# Access Compliance Report

## Public Rights-of-Way

Intersection ID: 53893	Main Street: PERTH_MOOR_RD	Cross Street: HAMILTON_BRIDGE_RD	Location: NE
ADA ID: 8467DBEB5183	Ramp Type: BlendTrans1	Initial Pass/Fail: Fail	Overall Compliance: No
Codes/Mitigation Info/Possible Solution		Field Measurements/Component Compliance	
Severity Score: 8.75

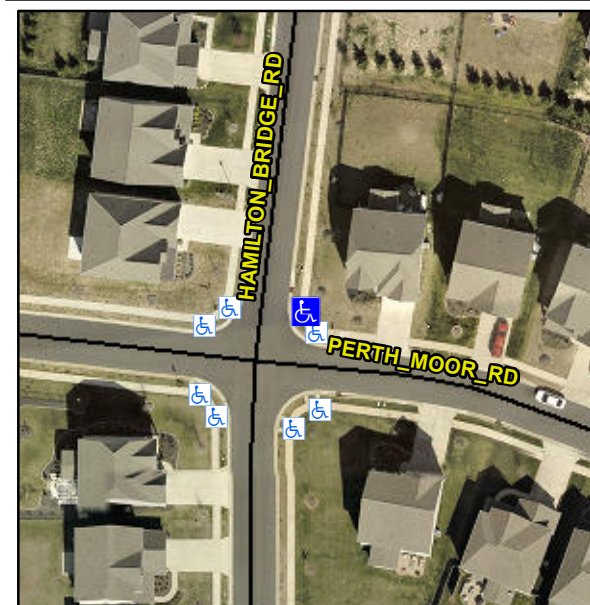
**Remove & Replace Curb Ramp With Two New Directional Ramps or Equivalent.**

**Not Found, R304.5.1**

Compliance	Description	Data	Compliance	Description	Data
N/A	Ramp Length (in)	49.0	Yes	BlendTrans Slope (%)	1.0
No	Ramp Width (in)	45.5	Yes	BlendTrans XSlope (%)	1.3
N/A	Flare Type LT	N/A	N/A	Flare Type RT	N/A
N/A	Flare Slope LT (%)	N/A	N/A	Flare Slope RT (%)	N/A
N/A	Flare Traversable LT?	N/A	N/A	Flare Traversable RT?	N/A
N/A	Landing Length (in)	N/A	N/A	DWS Provided?	N/A
N/A	Landing Width (in)	N/A	N/A	DWS Contrast?	N/A
N/A	Landing Slope (%)	N/A	N/A	DWS Length (in)	N/A
N/A	Landing X Slope (%)	N/A	N/A	DWS Full Width?	N/A
N/A	Landing Curb? (Y/N)	N/A	N/A	DWS Offset (in)	N/A
N/A	Shared Landing?	N/A			
N/A	Gutter Ponding?	N/A	N/A	Gutter Slope (%)	N/A
N/A	Gutter Lip Ht (in)	1.0	N/A	Gutter X Slope (%)	N/A
N/A	Painted X Walk1?	No	N/A	Painted X Walk2?	N/A
	X Walk 1 Direction	To W		X Walk 2 Direction	N/A
	X Walk 1 Width (in)	N/A		X Walk 2 Width (in)	N/A
	X Walk 1 Slope (%)	0.0		X Walk 2 Slope (%)	N/A
	X Walk 1 X Slope (%)	3.1		X Walk 2 X Slope (%)	N/A

N/A	Ramp inside XWalk1?	N/A	N/A	Ramp inside XWalk2?	N/A
	Road Slope (%)	3.1		Clear Space?	N/A
	Road X Slope (%)	0.0	N/A	Clear Space to XWalk (in)	N/A
N/A	Any Obstructions?	N/A	N/A	Storm Grate/Utility Hazard?	N/A
	Obstruction Type			Storm Grate/Utility Type	
		N/A			N/A
			Yes	Surface Condition? (G/P)	Good
			No	Curb Slope (%)	14.2
